## Application for URBAN DESIGN COMMITTEE Review

Date: October 1, 2014

## **Brookland Park Boulevard Streetscape Project Narrative and Scope of Work**

DESIGN BY: JO	REVIEWED BY:	FIELD NOTES:	SCALE: AS NOTED	DATE: 09/15/14	DRAWING NO.: 0-28558	SHEET NO.: 2F(1)
DRAWN BY: CL						
CHECKED BY: BM

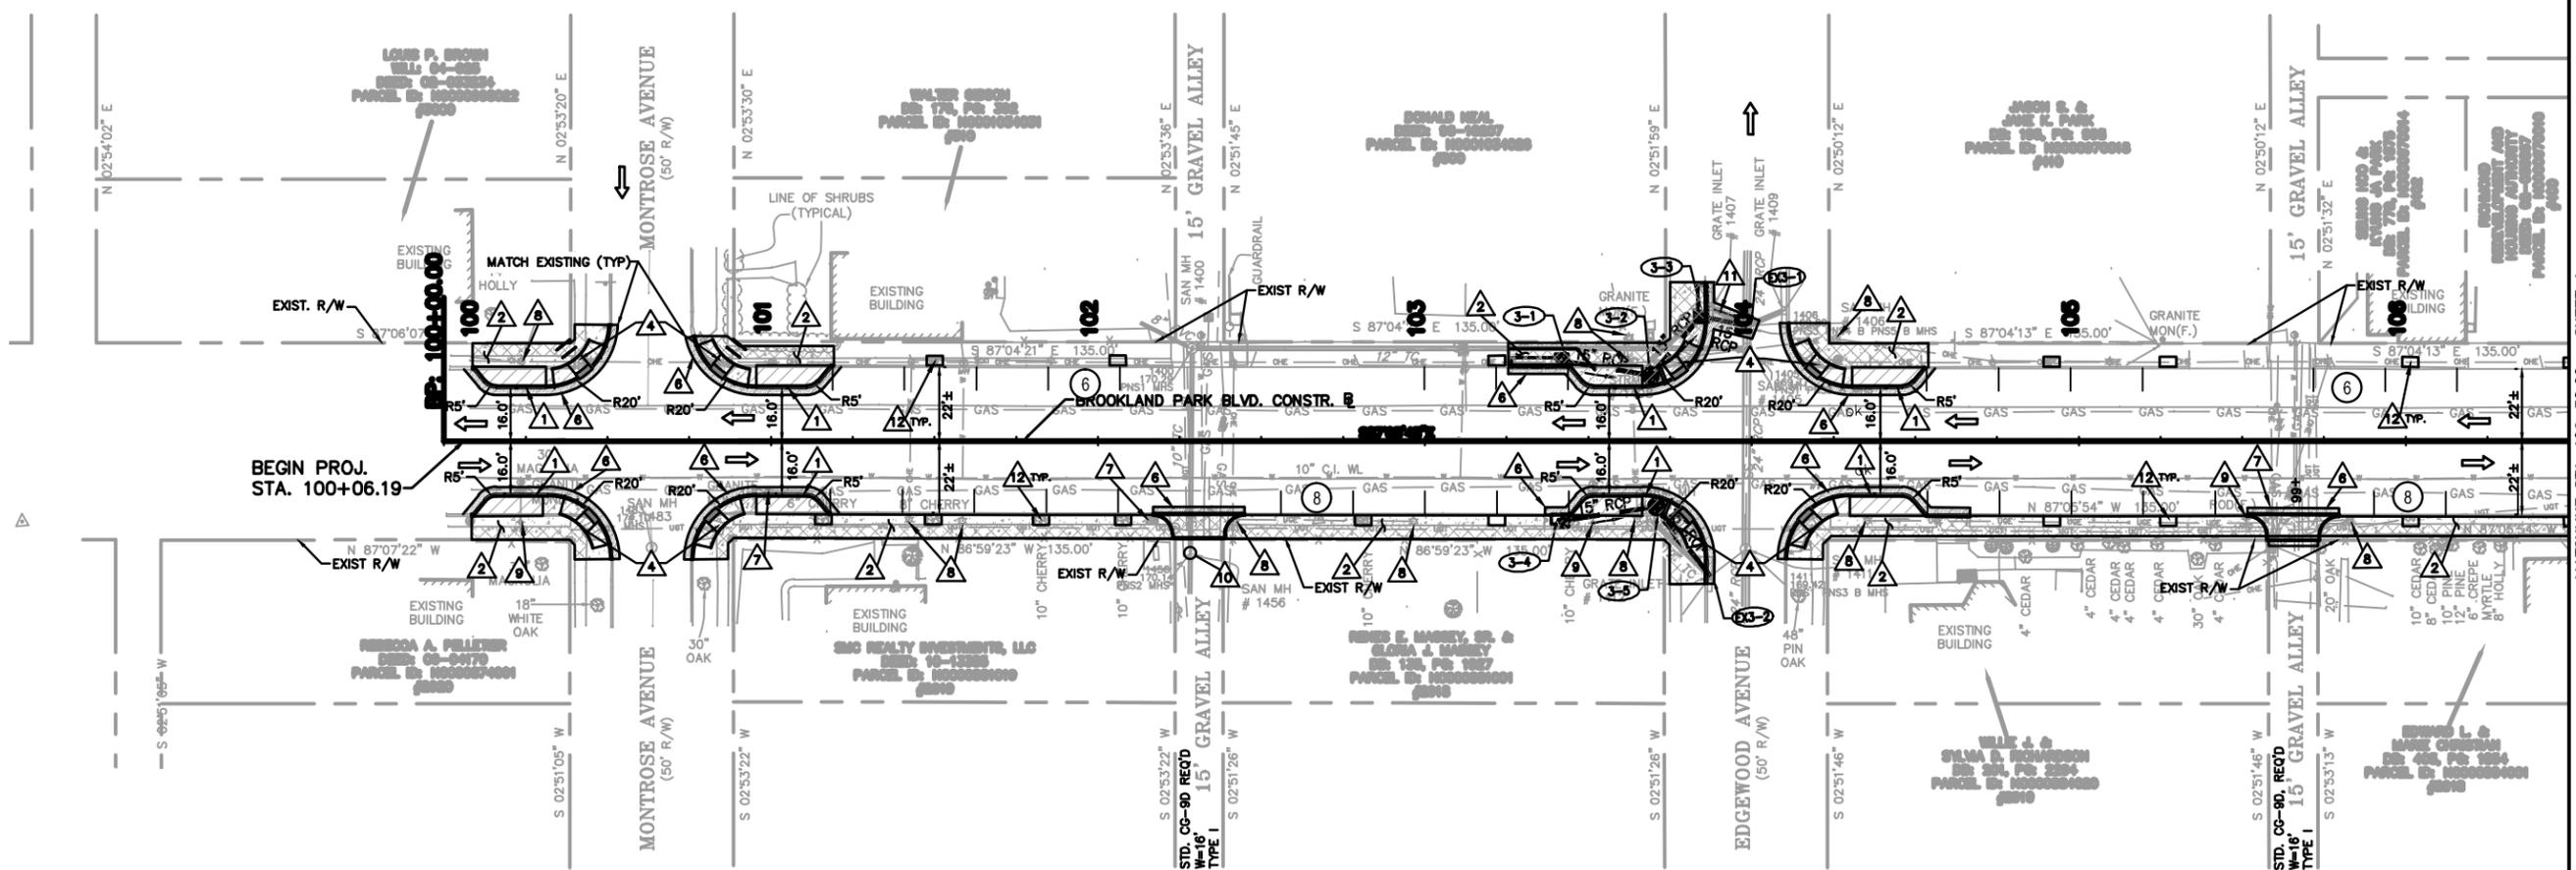
- 1- That the final plans show the location of any legal on-street parking spaces that will be lost as part of the improvement project.

- 2- That the final plans show the location and dimensions and of any GRTC bus stops along the project corridor.

(Sheet 2F(1) to 2F(2)) – The legal on-street parking spaces are shown.

(Sheet 2F(1) to 2F(2)) – The GRTC bus stops are shown.
